TECHNICAL MEMORANDUM TM-1050

AN/SQS-23 (PAIR) SONAR LETTER REPORT (U)

22 September 1965

PAIR/NTDS INTERFACE

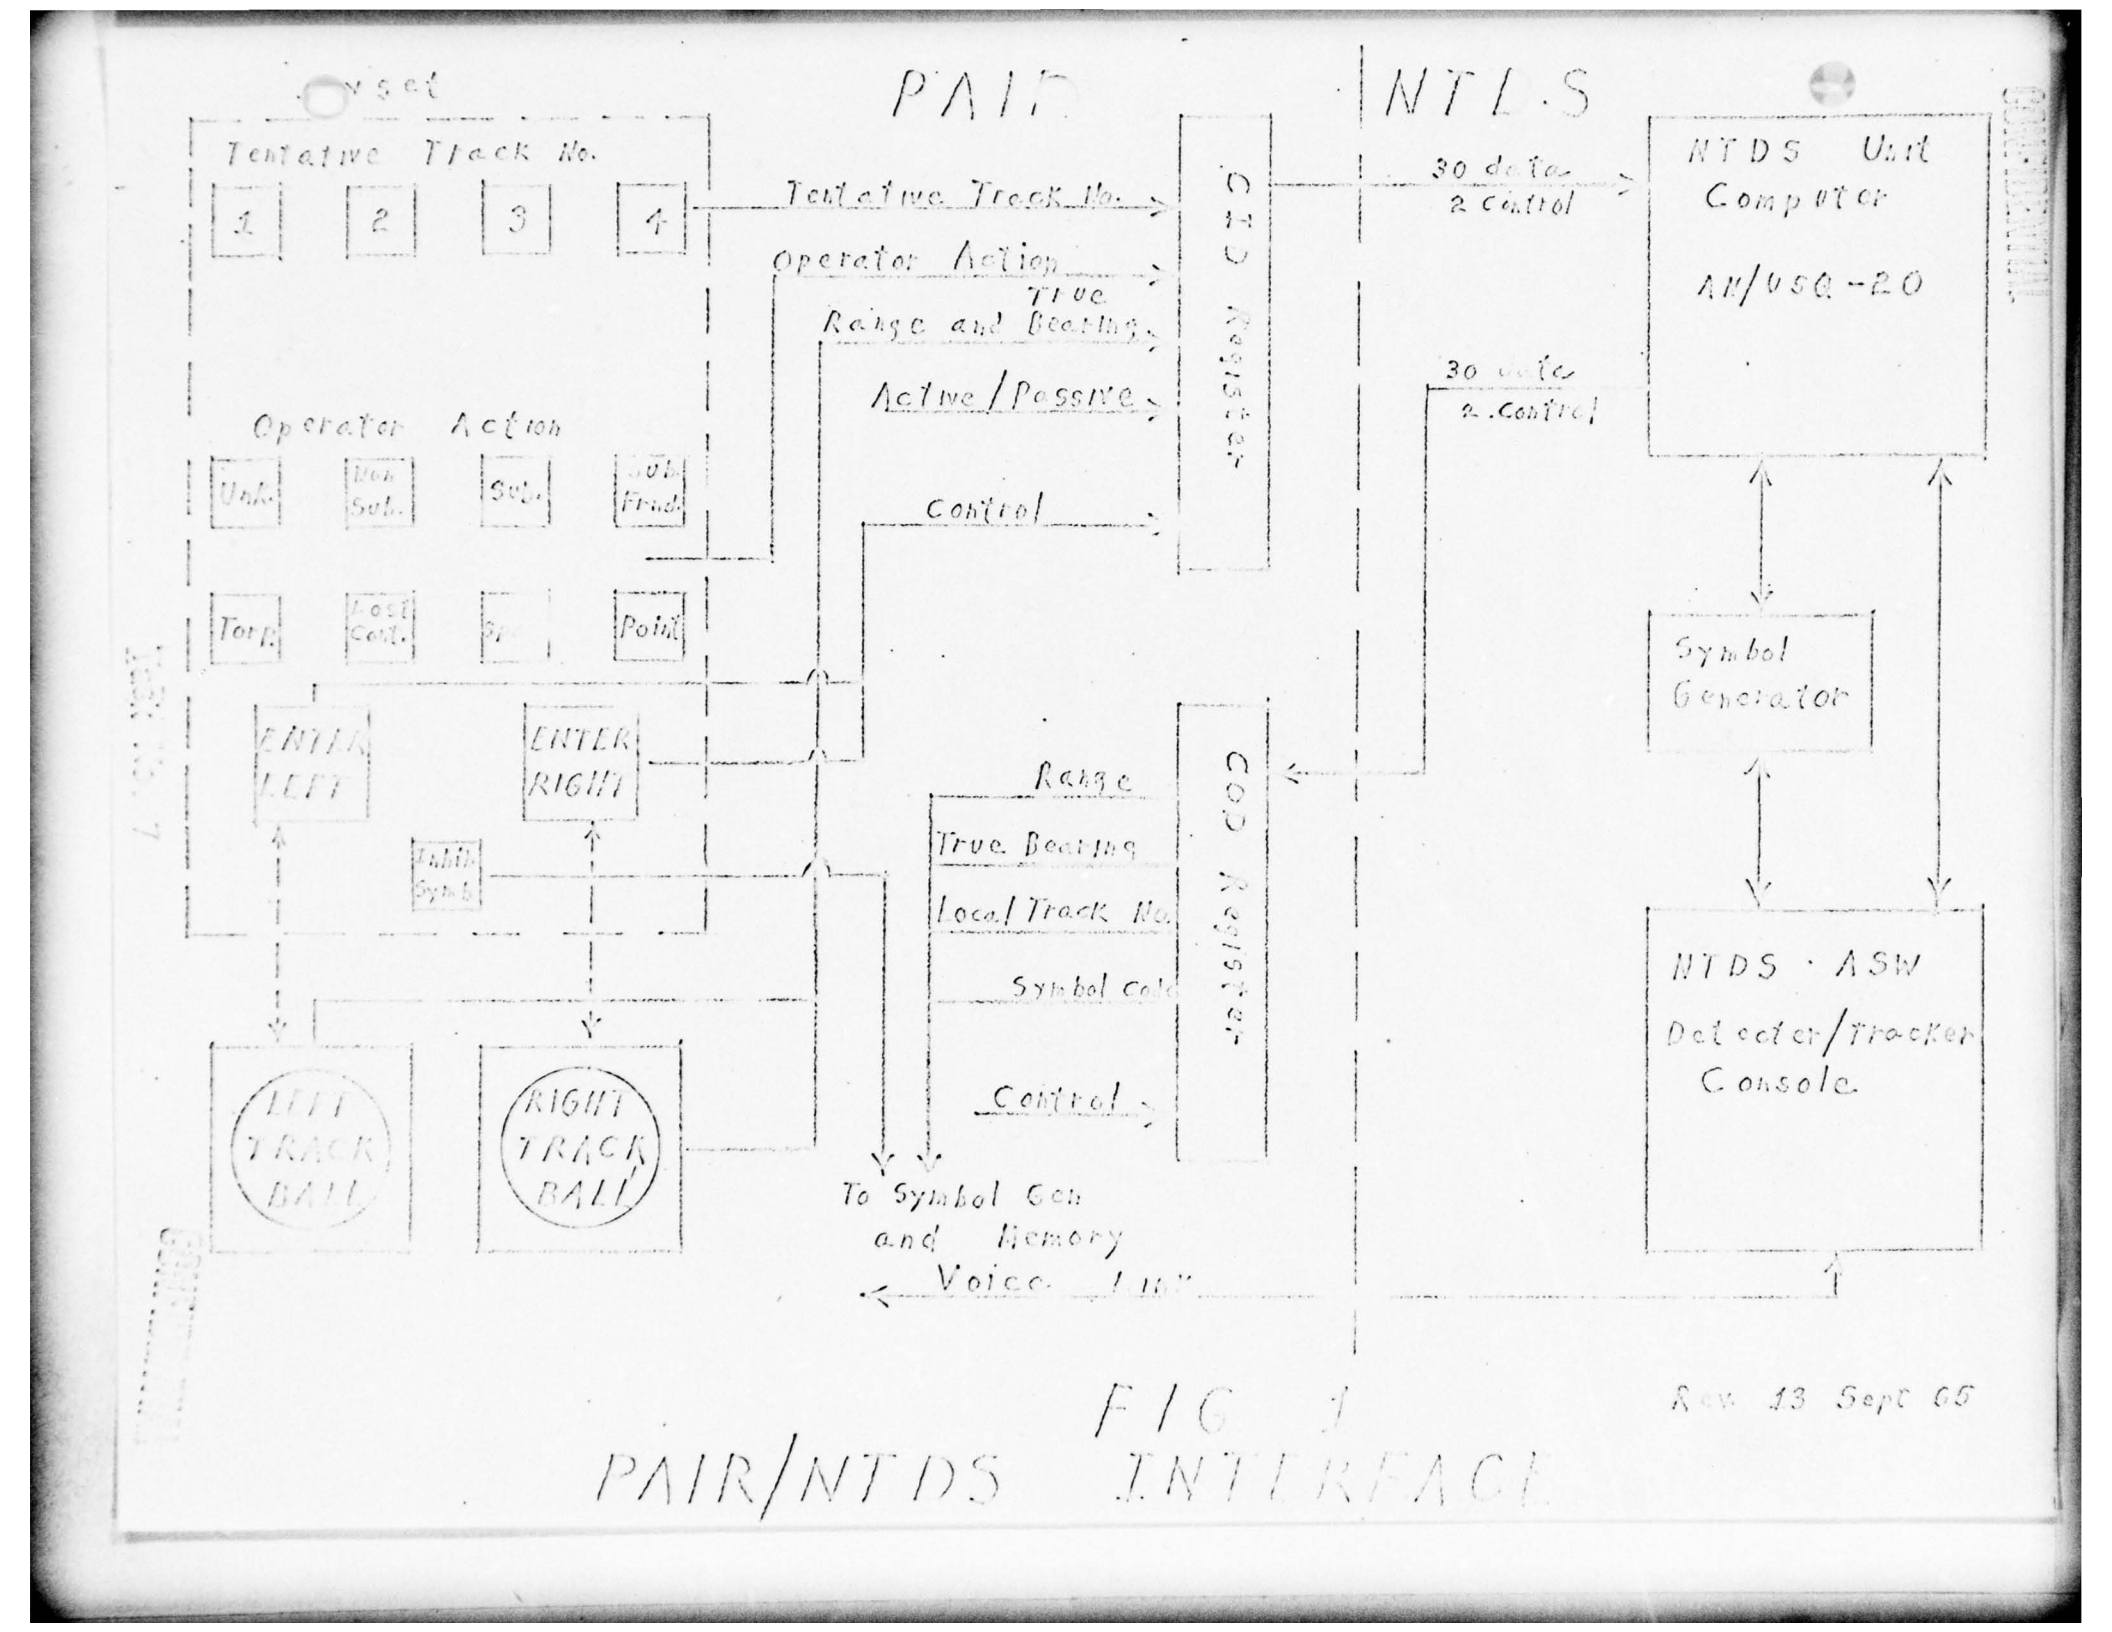
The basic PAIR/NTDS interface depicted in Figure 1, and treated in foregoing portions of this discussion has one serious drawback with respect to the AN/USQ-20. It ties up one complete computer Input/Output channel, rendering it unavailable for other uses. Inasmuch as the data rate across the subject interface is expected to be relatively low, this constitutes

inefficient usage of the I/O channel. The situation can be relieved to some extent by arranging for PAIR to share the computer channel with other equipments. This will increase the complexity of the required PAIR hardware to some extent, beyond that shown in Figure 1. Moreover, it will require that those devices sharing the channel with PAIR, conform to certain requirements to be described. Nevertheless, it is recommended that the PAIR/NTDS interface possess this channel sharing capability.

Figure 1 Proposed PPI Display
Task No. 8

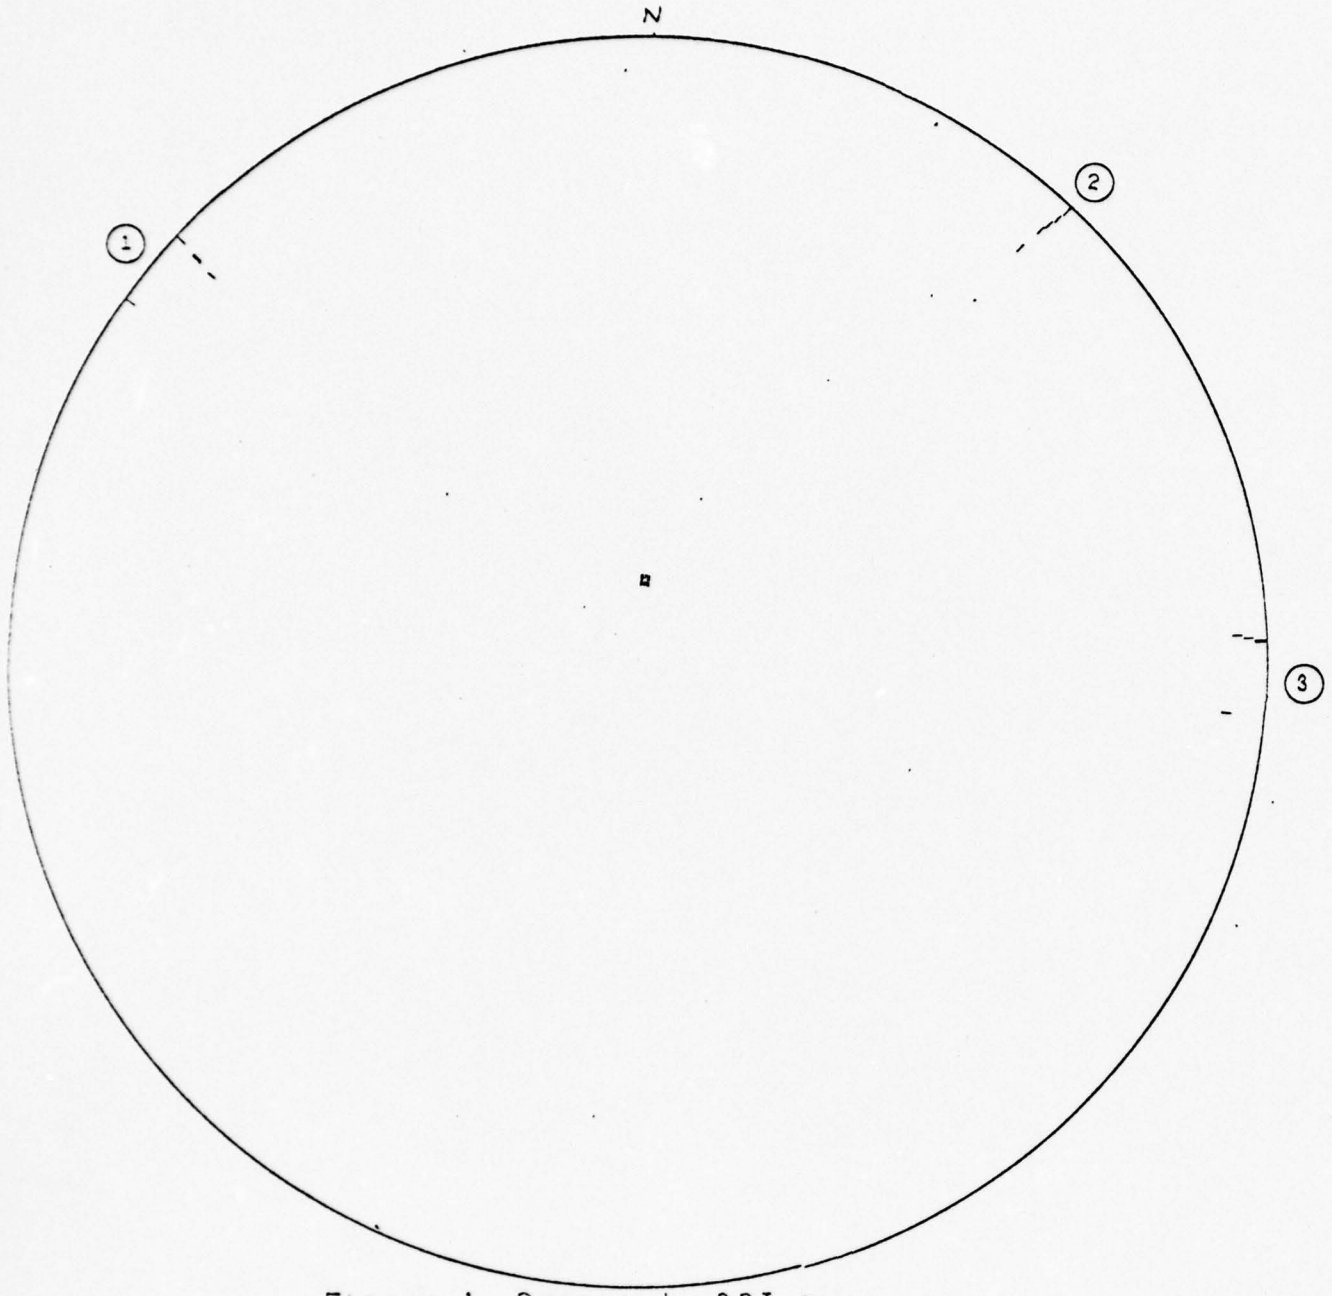
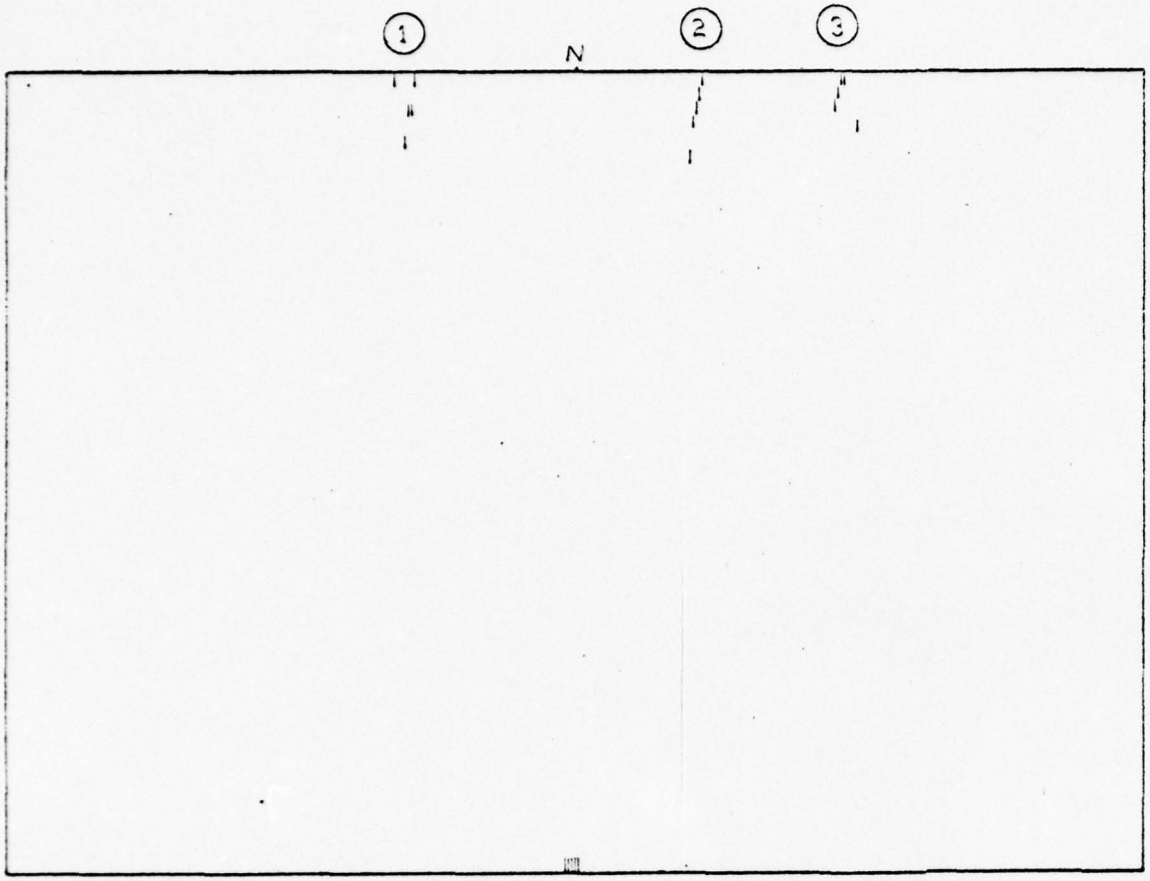
After considering the proposed spoked PPI display (See Figure 1) in some detail, we designed a B-scan format for the same size CRT (See Figure 2) for comparison purposes. We will illustrate that this B-scan has a number of significant advantages over the proposed PPI. Included in these advantages are larger and more easily distinguished event mark sizes and spacings, more easily detectable patterns for targets moving in either range or bearing, more effective utilization of the available display area, and better correlation between track ball motion and cursor motion.

Utilization of the display area on the proposed 10" circular PPI screen is very poor (19.5%). The proposed B-scan utilizes 62.8% of the rectangular 8.4" x 6" area selected. The larger range dimension on the proposed B-scan (6" vs. 4.4" for the PPI) provides a longer event mark and has the added advantage of easier positioning of the cursor in range for handoff to the TCD. This is particularly critical in the single ping mode where the detection display has 240 range bins. This range dimension could be further increased without an objectionably large CRT by going to a rectangular tube screen.

2. Section 3.4.5.12 - Change: "For search operations a PPI-scan shall be provided" to: "For search operations a PPI and/or B-scan shall be provided". Add: "Choice of PPI and/or B-scan for search operations will be decided by ASWSPO after further simulation and analysis." Therefore delete Figure 6.

Figure 1

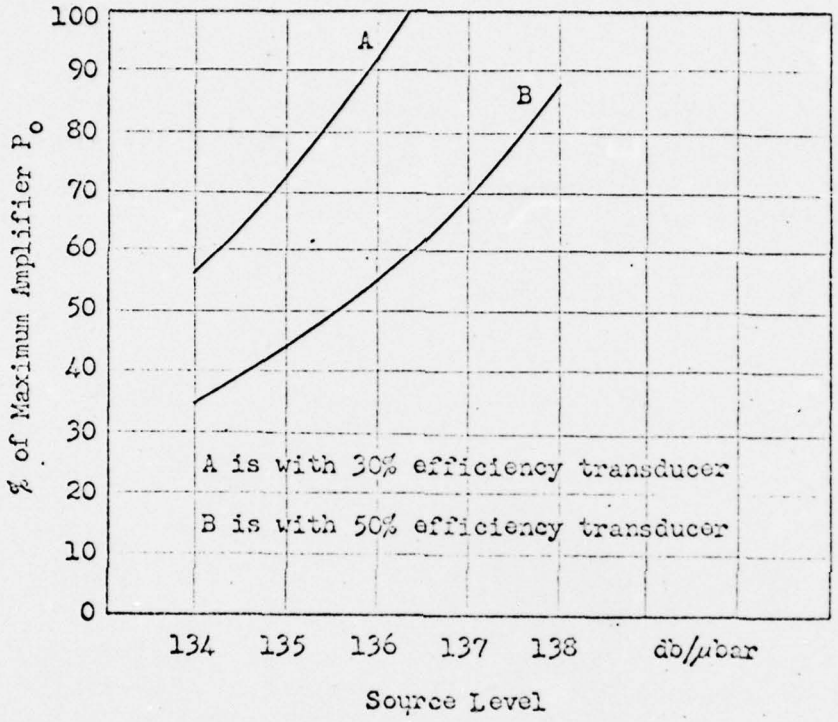
To maintain a source level of 135 db/μbar in the 128 millisecond, 300° RDT mode of operation (worse case), each transducer element will have to accept 15.0 watts average input power for the 50% efficient units and 24.7 watts average for the 30% units (Figure 2). All the transducers can handle the required power at 5 kc, however, TR-197, TR-177 and TR-152 fall to efficiencies less than 30% within the proposed operating frequency range thus making the required input power too great for the long duty cycle required.

The stated efficiency of the Harris TR-191 and Massa TR-028 transducers is greater than 60%. Specifications for the Sangamo TR-177, Bendix TR-152 and Raytheon TR-197 require only 30%. Since the TRAM modification reduces the power handling capabilities of the transmitter section, the lower efficiency of the later group would require operating the amplifiers above 70% of maximum capability to maintain satisfactory source level (Figure 1). This additional load will reduce the transmitter reliability.

FIGURE 1
TASK 26

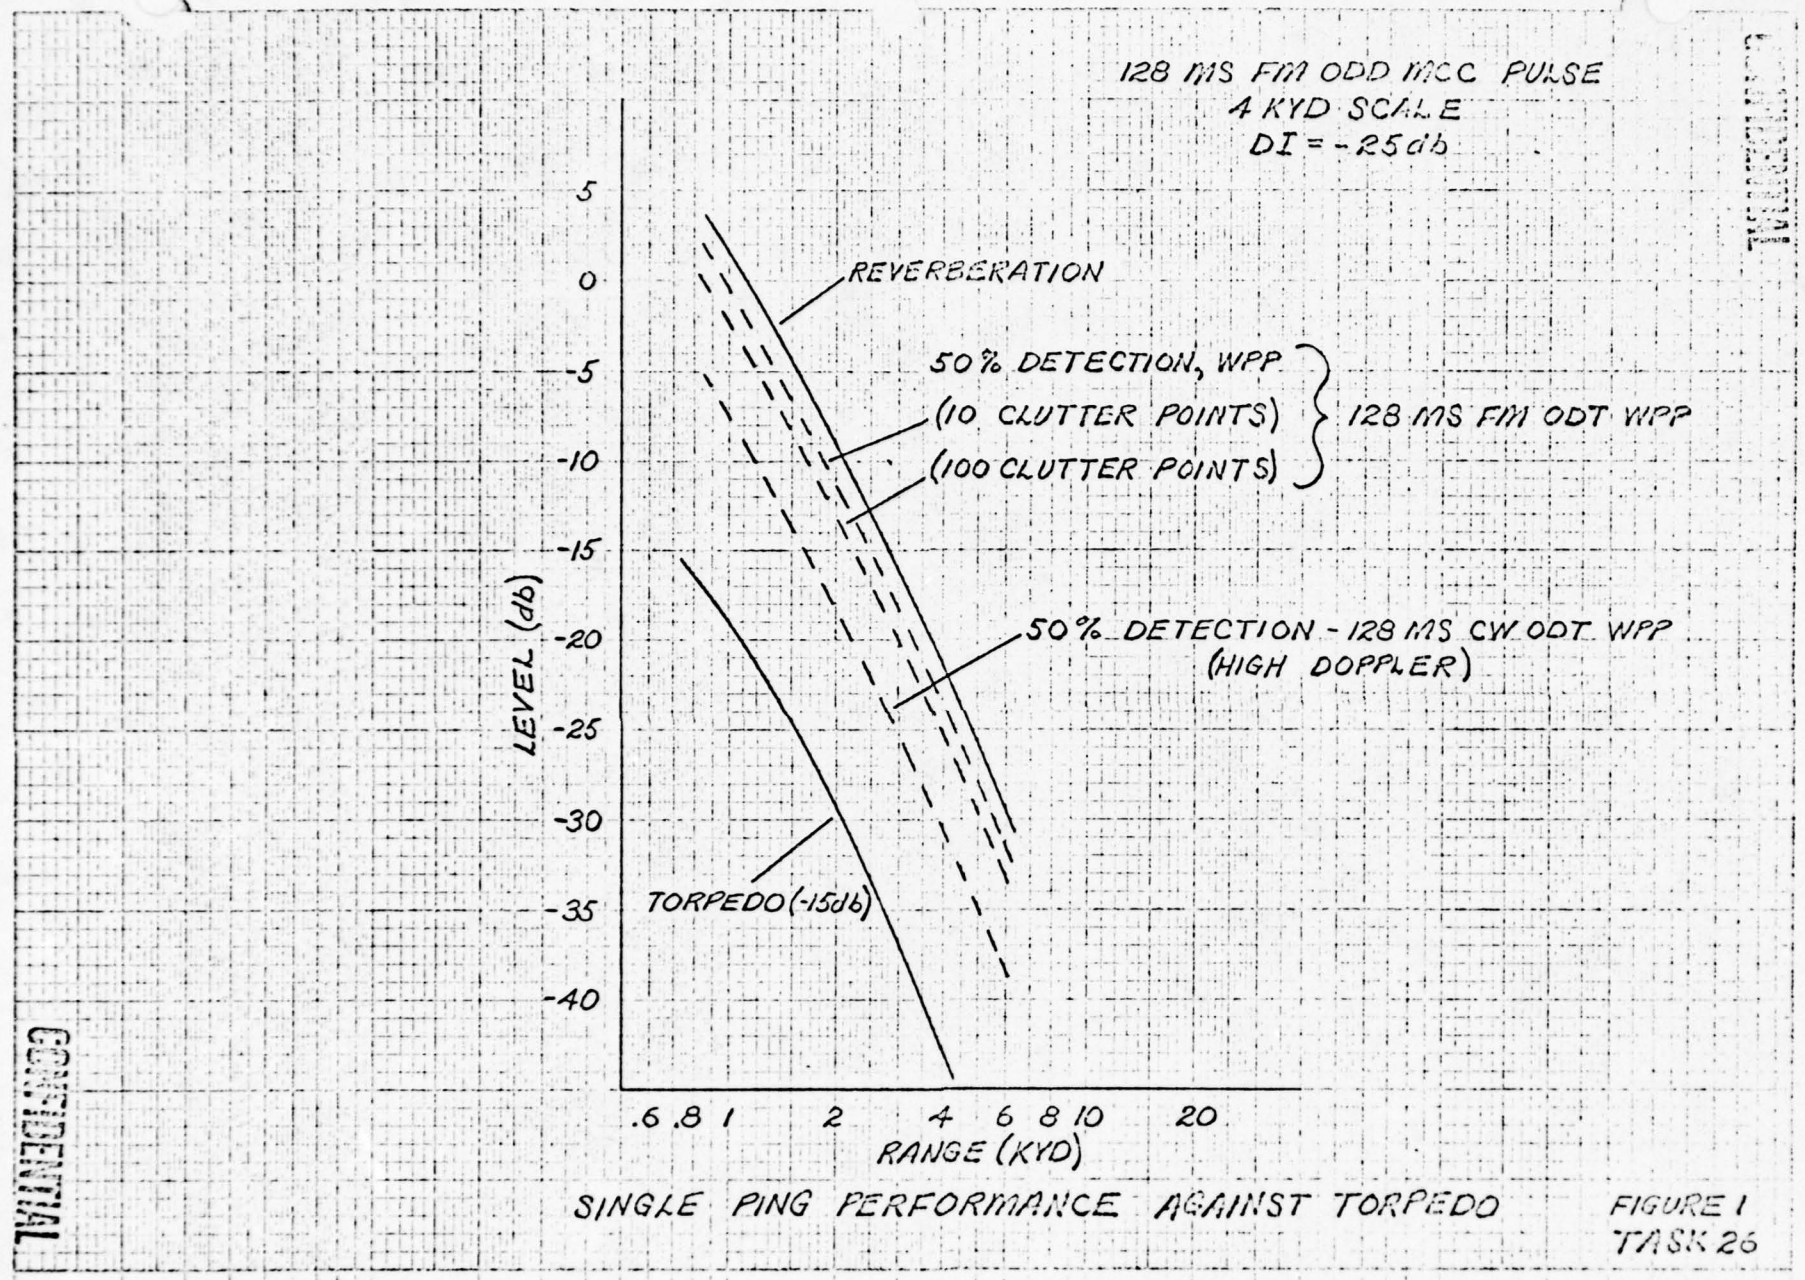
When reverberation levels, noise levels, and target levels are plotted as a function of range for a typical torpedo at $\pm 45^{\circ}$ aspect the torpedo level is found to lie 10 db or more below the levels required for 50% detection using the wave period processor with either FM or CW pulses and the assumption of high doppler. Typical estimates are shown in sea state 4 for a target strength of -15 db in Figure 1. The dashed plots are the 50% detection levels for the specified clutter. The probability that a torpedo will be detected by the active system is extremely low.
